Access Compliance Report

Public Rights-of-Way

(Curb Ramps)

Intersection ID: 21519	Main Street: AMYINGTON_DR	Cross Street: COLONY_RD	Location:	N
ADA ID: 84653B1527DF	Ramp Type: Perp	Initial Pass/Fail: Fail	Overall Compliance: No	Severity Score: 21.25
Codes/Mitigation Info/Possible Solution		Field Measurements/Component Compliance

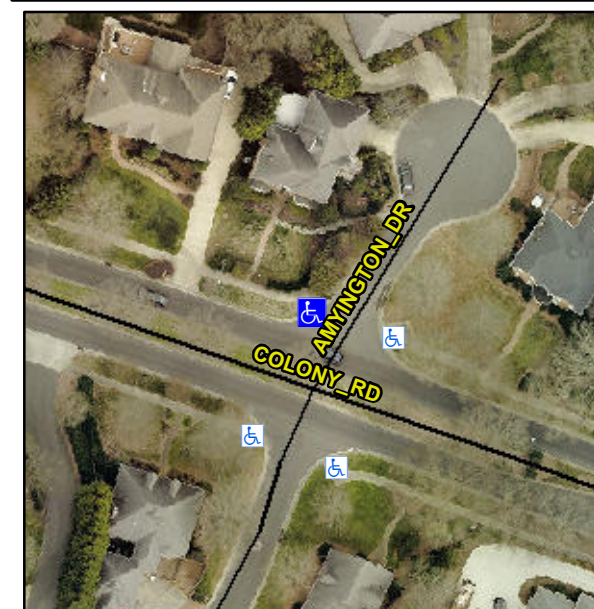
Not Found, R304.5.1, R304.5.3

Compliance	Description	Data	Compliance	Description	Data
N/A	Ramp Length (in)	104.0	Yes	Ramp Slope (%)	5.2
No	Ramp Width (in)	36.0	No	Ramp XSlope (%)	5.8
N/A	Flare Type LT	N/A	N/A	Flare Type RT	N/A
N/A	Flare Slope LT (%)	N/A	N/A	Flare Slope RT (%)	N/A
N/A	Flare Traversable LT?	N/A	N/A	Flare Traversable RT?	N/A
N/A	Landing Length (in)	N/A	N/A	DWS Provided?	N/A
N/A	Landing Width (in)	N/A	N/A	DWS Contrast?	N/A
N/A	Landing Slope (%)	N/A	N/A	DWS Length (in)	N/A
N/A	Landing X Slope (%)	N/A	N/A	DWS Full Width?	N/A
N/A	Landing Curb? (Y/N)	N/A	N/A	DWS Offset (in)	N/A
N/A	Shared Landing?	N/A			
N/A	Gutter Ponding?	N/A	N/A	Gutter Slope (%)	N/A
N/A	Gutter Lip Ht (in)	N/A	N/A	Gutter X Slope (%)	N/A
N/A	Painted X Walk1?	No	N/A	Painted X Walk2?	N/A
	X Walk 1 Direction	To SE		X Walk 2 Direction	N/A
N/A	X Walk 1 Width (in)	N/A	N/A	X Walk 2 Width (in)	N/A
	X Walk 1 Slope (%)	5.6		X Walk 2 Slope (%)	N/A
	X Walk 1 X Slope (%)	1.4		X Walk 2 X Slope (%)	N/A

Remove & Replace Entire Ramp.
